Date: JUN 07 2017
Symbol: EPC-DO: 17-196
LA-UR: 17-22189
Locates Action No.: N/A

Subject: Notification of Class 1 Permit Modification Facility Description Updates for the Technical Area 63 Transuranic Waste Facility Container Storage Unit, Los Alamos National Laboratory Hazardous Waste Facility Permit, EPA I.D. #NM0890010515 (NA/LA)

**Class 1 Permit Modification
Facility Description Updates for the
Technical Area 63 Transuranic Waste Facility
Container Storage Unit,
Los Alamos National Laboratory
Hazardous Waste Facility Permit**

Figure 55, Technical Area TA) 63 Transuranic Waste Facility

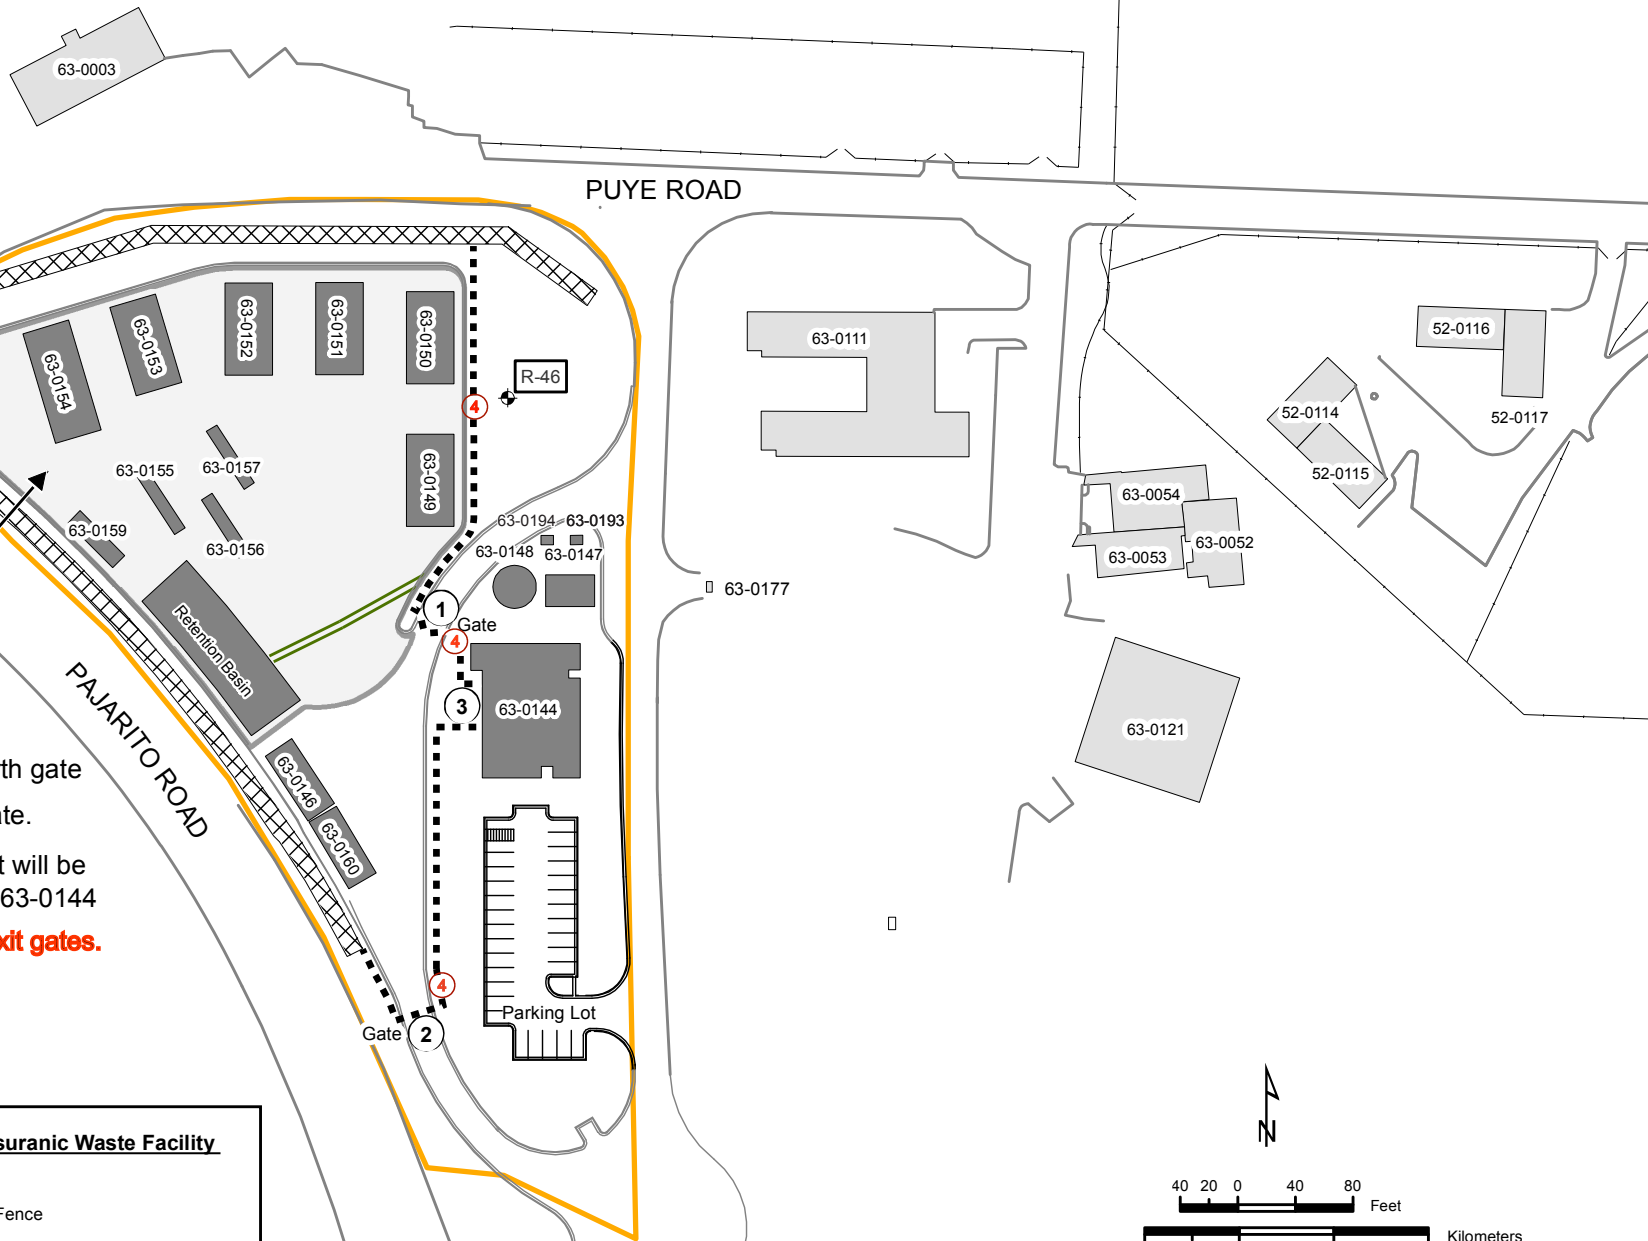
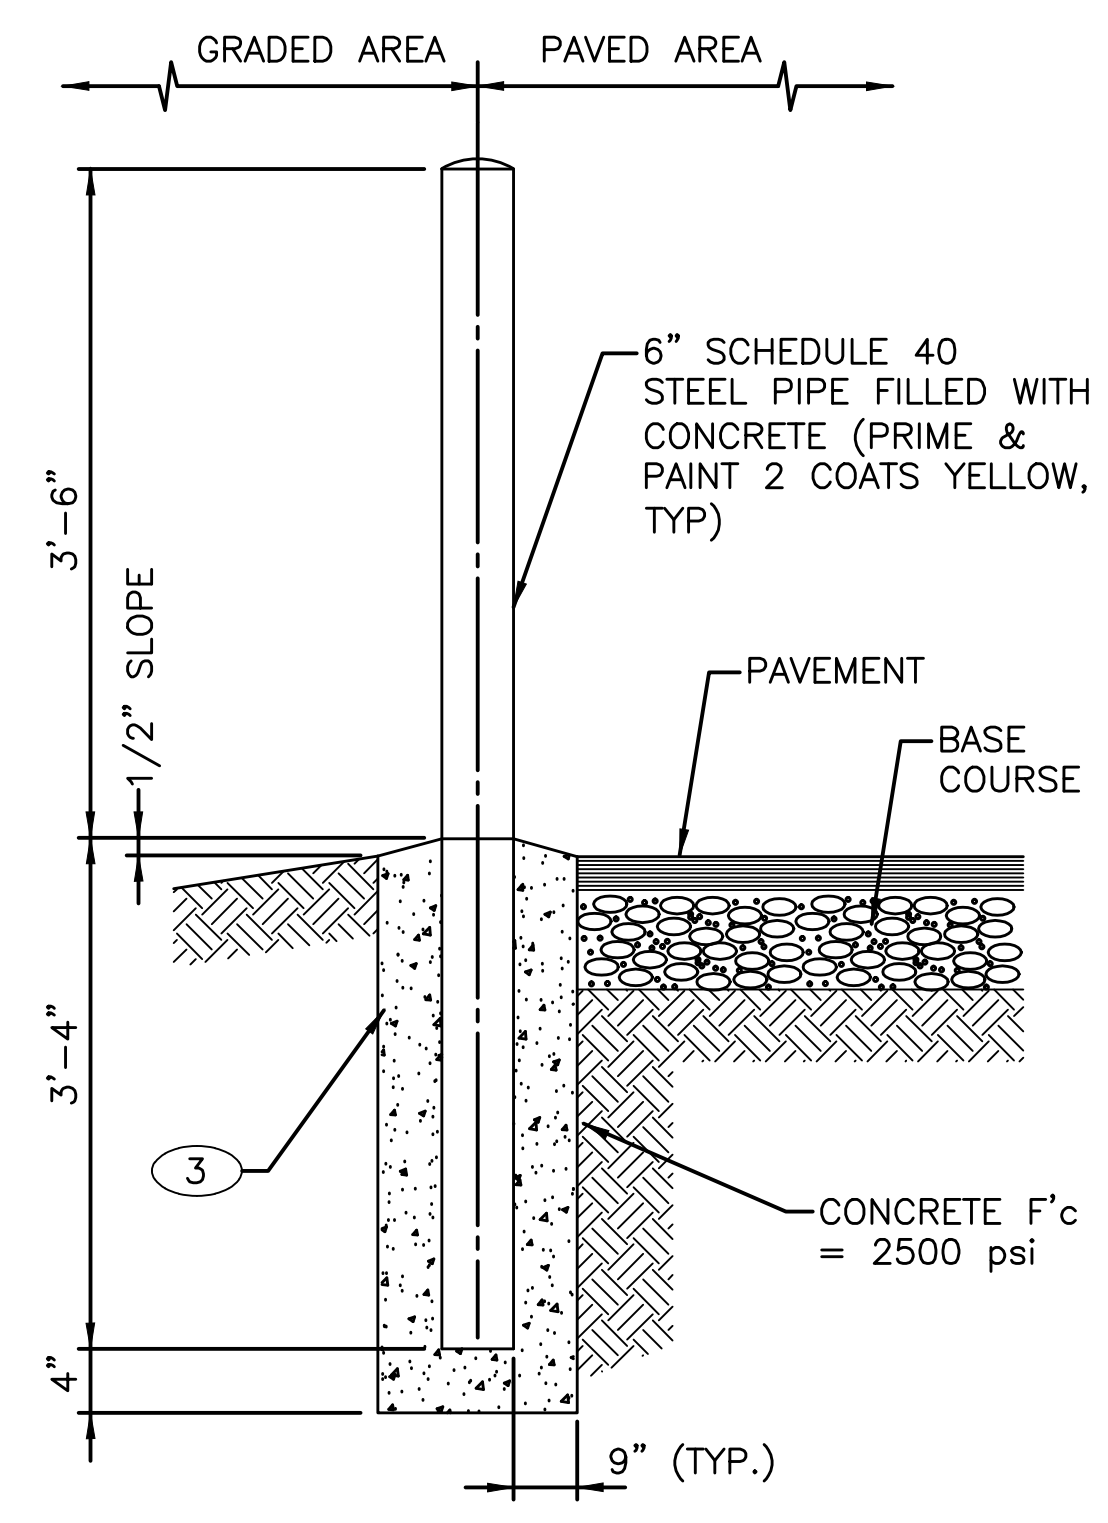
Permit Section A.6.6, *Other Project Structures*, Permit Figure 55, *Technical Area (TA) 63 Transuranic Waste Facility*, and Permit Figure G.27-1, *Transuranic Waste Facility Soil Sampling Grid*, have been revised to include descriptions and locations of two equipment structures associated with the TA-63 TWF. The two concrete structures are located north of TA-63-0144 (the Operations Support Building), are not within the permitted storage unit and are not used to manage hazardous waste containers. The structures are concrete enclosures for two seismic power cutoff systems. The seismic systems are control relays used to shut off power to the TA-63 TWF waste storage buildings and characterization trailers in the event of an earthquake to prevent potential electrical fires involving waste containers. A sentence has been added to Permit Section A.6.6 stating that two seismic power cutoff system enclosures are present north of the Operations Support Building. Figure 55 has been revised to provide the location of the concrete structures. Figure G.27-1 has been revised to show the location of the concrete structures and also to provide other changes updating the depiction of the surrounding area such as removed buildings, parking lots, and the facility vehicle barrier. Attachment 4 includes these revisions.

Permit Figure 55, <i>Technical Area (TA) 63 Transuranic Waste Facility</i>	Addition of two facility structures	A.1	The change is needed in the facility description to add two non-waste management systems support structures associated with the facility.

PEDESTRIAN GATE DETAIL

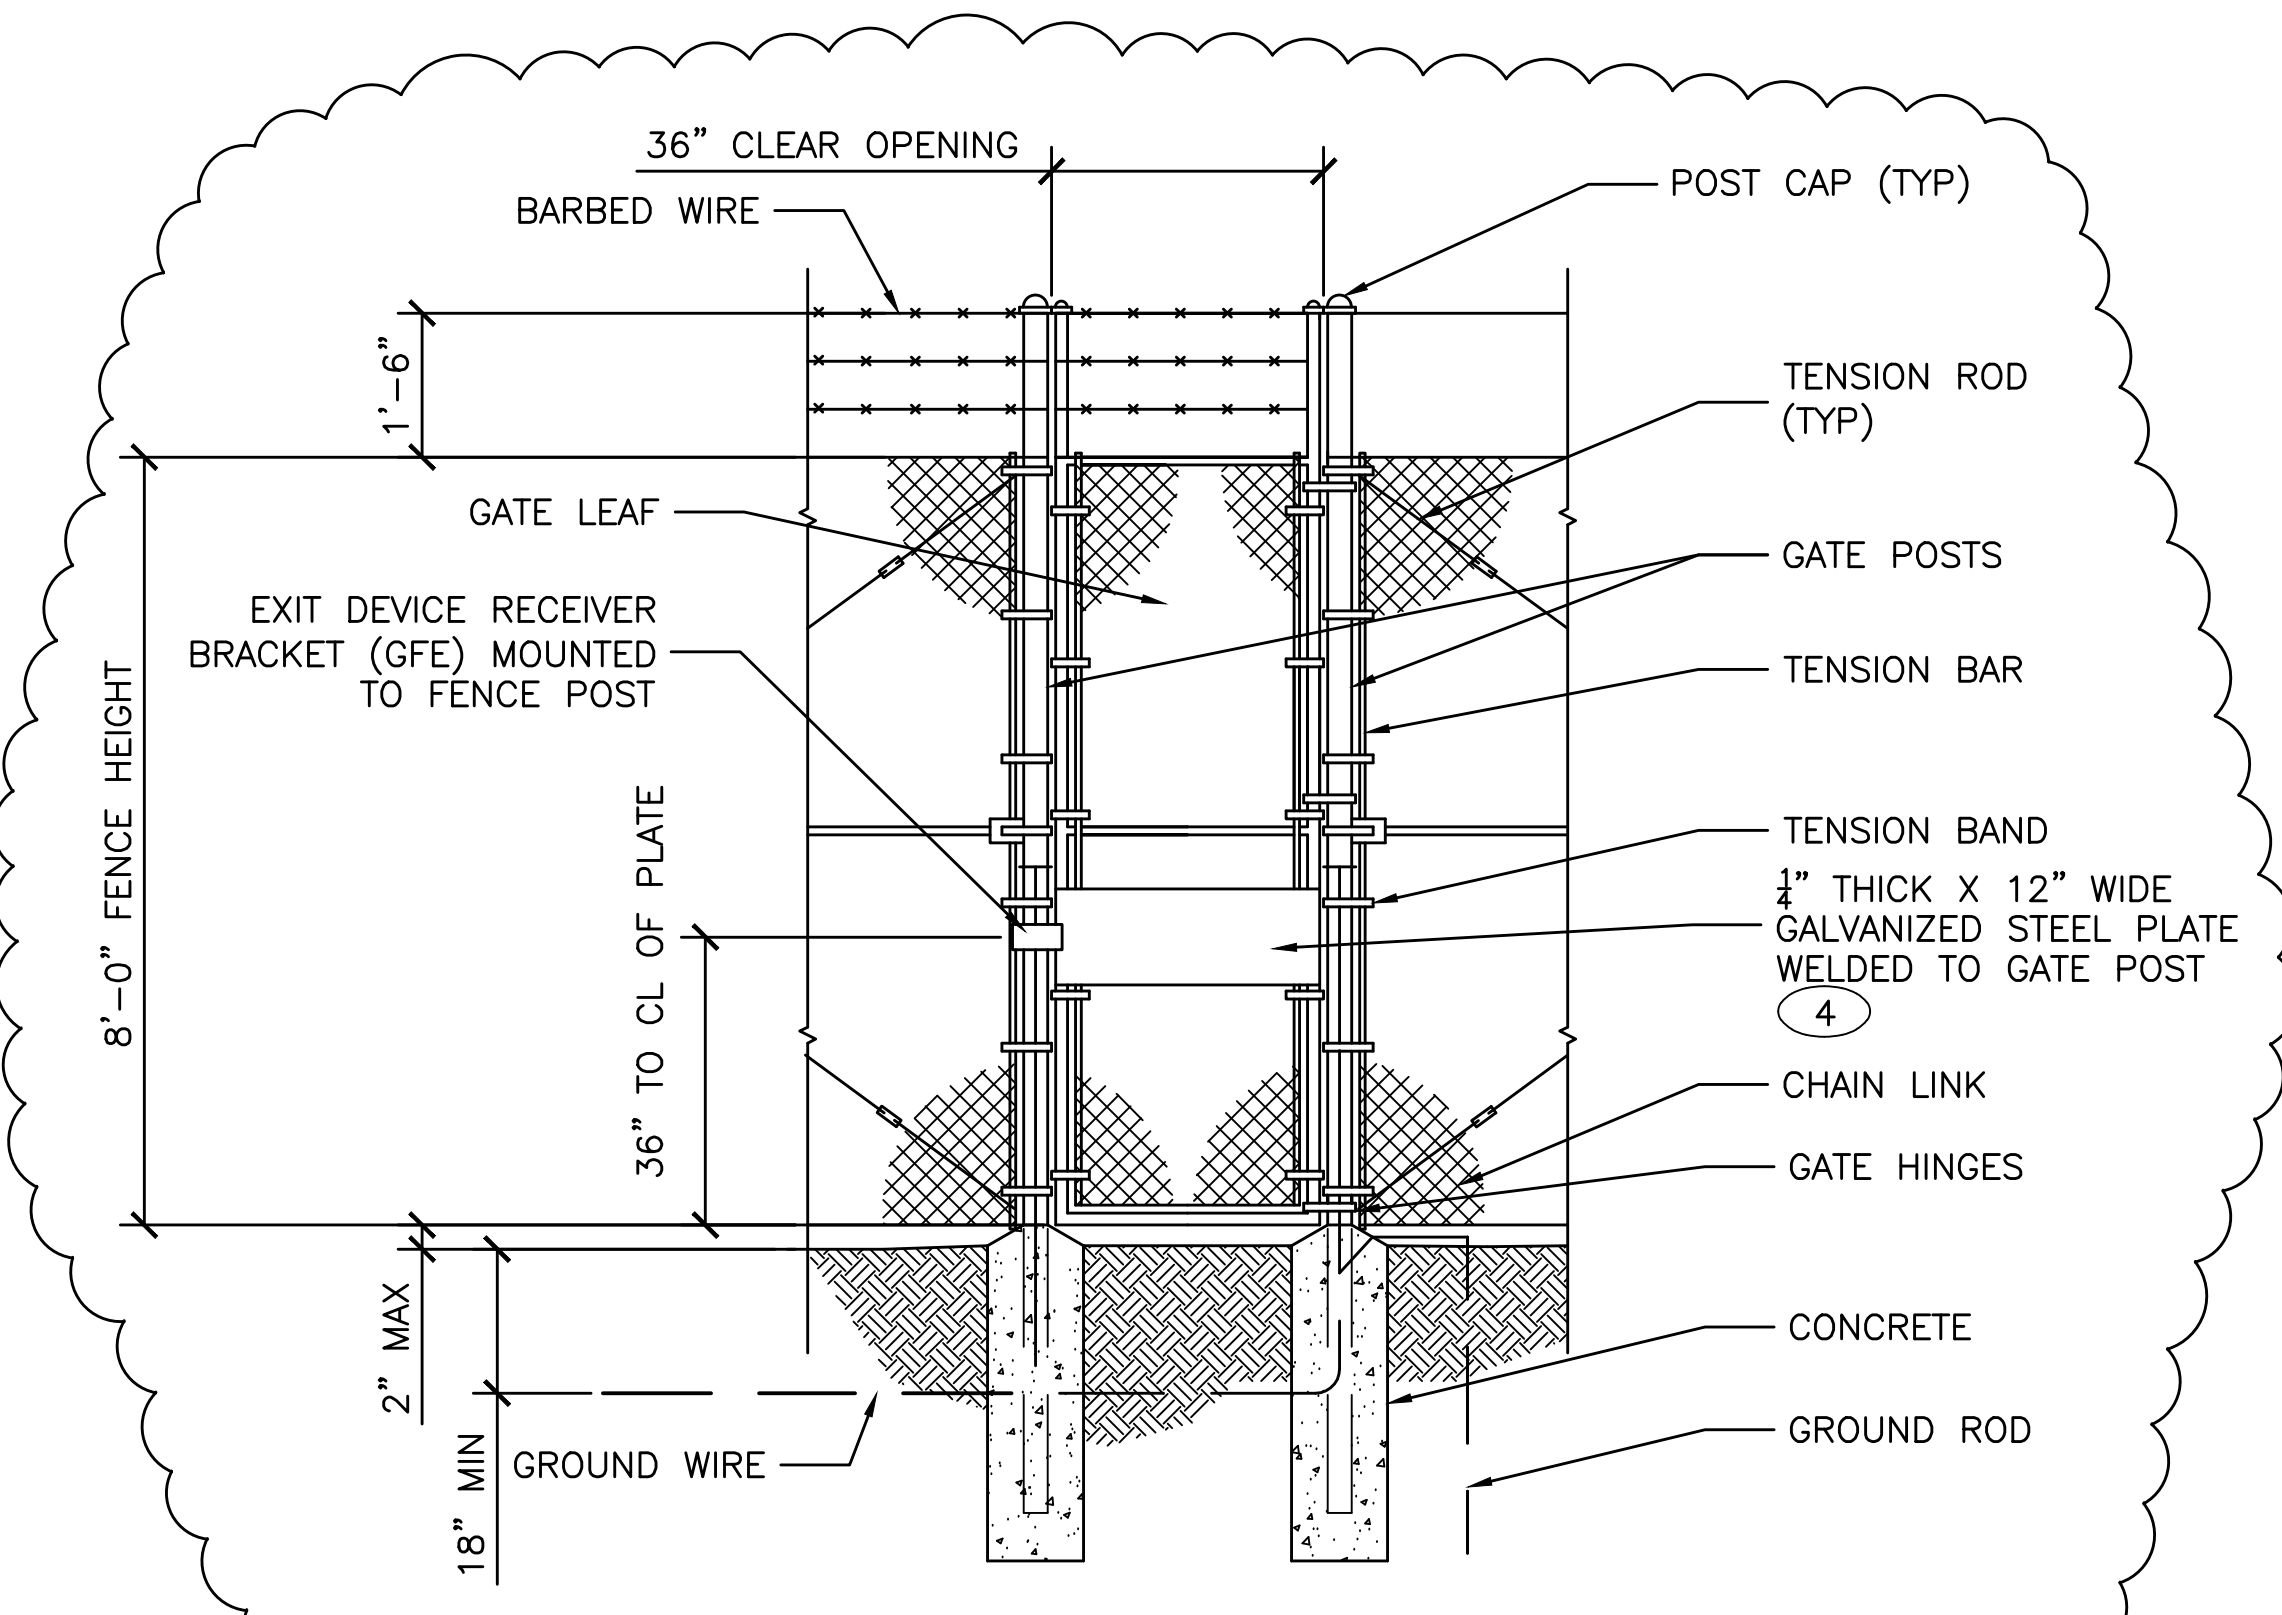
Three emergency personnel exit gates (crash gates) are present in the security fence as constructed for the TA-63 TWF on the east and south sides. These gates are opened from the inside of the fence line for the purpose of aiding the exit of personnel in emergency situations. They are not routinely kept open for any other purpose and are a security feature of the fence because they cannot be opened from the outside. Figure 55, *Technical Area (TA) 63 Transuranic Waste Facility* and Permit Section A.6.7, *Security and Access Control*, are revised to include the gates in the facility description and provide their locations. Revision details are included in Attachment 3. Figure 55 has been modified to show the location of the three gates and a descriptive note has been added. A sentence has been added to Permit Section A.6.7 stating:

“Three emergency personnel one-way exit gates are also present in the fence.” Attachment 3 also includes a facility construction figure with gate details previously submitted in the TA-63 TWF Construction Notice (LANL, 2017).
